Access Compliance Report

Public Rights-of-Way

Intersection ID: 18900	Main Street: CLIFTON_MEADOW_DR	Cross Street: TWIN_FALLS_LN	Location: SW
ADA ID: 45539F1A664F	Ramp Type: PerpDiag	Initial Pass/Fail: Fail	Overall Compliance: No
Severity Score: 25			
Codes/Mitigation Info/Possible Solution		Field Measurements/Component Compliance

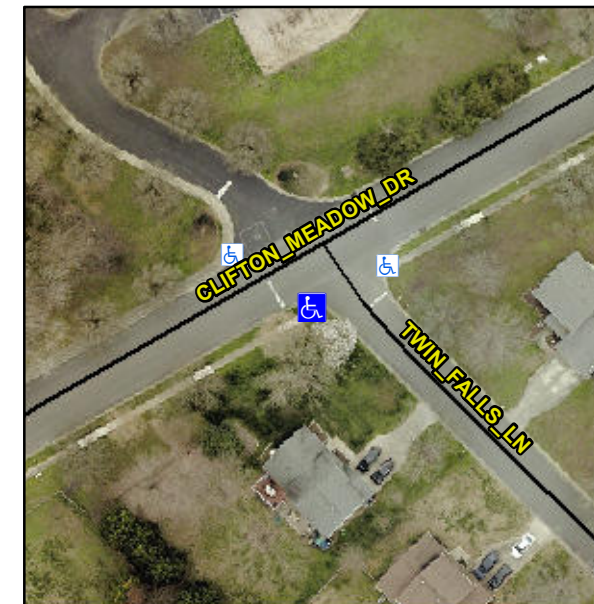
Not Found, R304.5.3

Compliance	Description	Data	Compliance	Description	Data
N/A	Ramp Length (in)	36.0	Yes	Ramp Slope (%)	5.7
Yes	Ramp Width (in)	48.0	No	Ramp XSlope (%)	7.9
N/A	Flare Type LT	N/A	N/A	Flare Type RT	N/A
N/A	Flare Slope LT (%)	N/A	N/A	Flare Slope RT (%)	N/A
N/A	Flare Traversable LT?	N/A	N/A	Flare Traversable RT?	N/A
N/A	Landing Length (in)	N/A	N/A	DWS Provided?	N/A
N/A	Landing Width (in)	N/A	N/A	DWS Contrast?	N/A
N/A	Landing Slope (%)	N/A	N/A	DWS Length (in)	N/A
N/A	Landing X Slope (%)	N/A	N/A	DWS Full Width?	N/A
N/A	Landing Curb? (Y/N)	N/A	N/A	DWS Offset (in)	N/A
N/A	Shared Landing?	N/A			
N/A	Gutter Ponding?	N/A	N/A	Gutter Slope (%)	N/A
N/A	Gutter Lip Ht (in)	N/A	N/A	Gutter X Slope (%)	N/A
N/A	Painted X Walk1?	No	N/A	Painted X Walk2?	No
	X Walk 1 Direction	To NE		X Walk 2 Direction	To NW
N/A	X Walk 1 Width (in)	N/A	N/A	X Walk 2 Width (in)	N/A
	X Walk 1 Slope (%)	6.9		X Walk 2 Slope (%)	2.9
	X Walk 1 X Slope (%)	0.1		X Walk 2 X Slope (%)	9.8

Remove & Replace Curb Ramp With Two New Directional Ramps or Equivalent.
